Appendix E
Comments on Draft SEIS and Responses

Appendix E Comments on the Draft SEIS and Responses

This appendix contains the written and oral comments received on the draft SEIS prepared for Xcel Energy’s proposed change in spent fuel storage technology at the PINGP ISFSI, as well as responses to these comments. The draft SEIS was issued on February 1, 2022. Comments on the draft were solicited by EERA staff through two public meetings, a meeting with the Prairie Island Indian Community, and a public comment period. The public comment period ended on March 3, 2022.

RE: Draft Supplemental Environmental Impact Statement for the Proposed Change in
Technology at the Prairie Island Nuclear Generating Plant (Docket No. CN-08-510)

Fig. 1 - 10-mile radius from Prairie Island Nuclear Generating Plant - Emergency Planning Zone (shaded area)

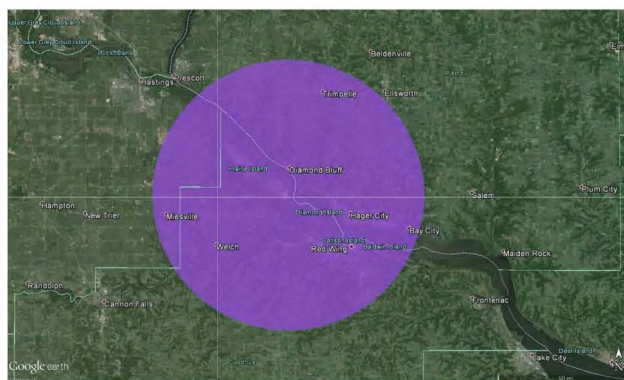
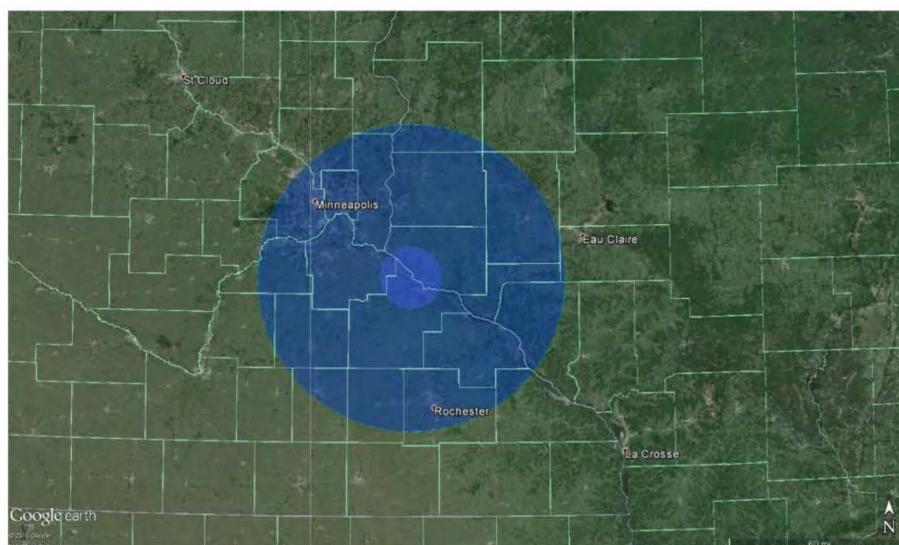
The SEIS notes that there are “relatively few persons that live near the PINGP” and that Red Wing is six miles to the southeast. SEIS p. 30, Section 4.3. Earlier, it claims 450 residents within PIIC, which is not “relatively few persons.” Red Wing, home to just over 16,000, is directly downriver and downwind, and in nuclear terms, that distance is very small. That six miles is within the first ring 10 mile Emergency Planning Zone, so within 10 miles, PIIC, Red Wing, and more miles out means that roughly 20,000 people live within the first ring EPZ.

The 2nd EPZ is a 50 mile radius from the plant, above, and includes Minneapolis and much of Hennepin County; St. Paul and all of Ramsey County; much of Scott County; all of Dakota, Washington, Rice, Goodhue and Wabasha counties, Rochester and parts of Olmsted, Dodge and Steele Counties; St. Croix, Dunn, Pierce, Pepin Buffalo Counties in Wisconsin, which presents

significant potential for human impacts. The SEIS must at least note the wide range of the 10 and 50 mile EPZs.
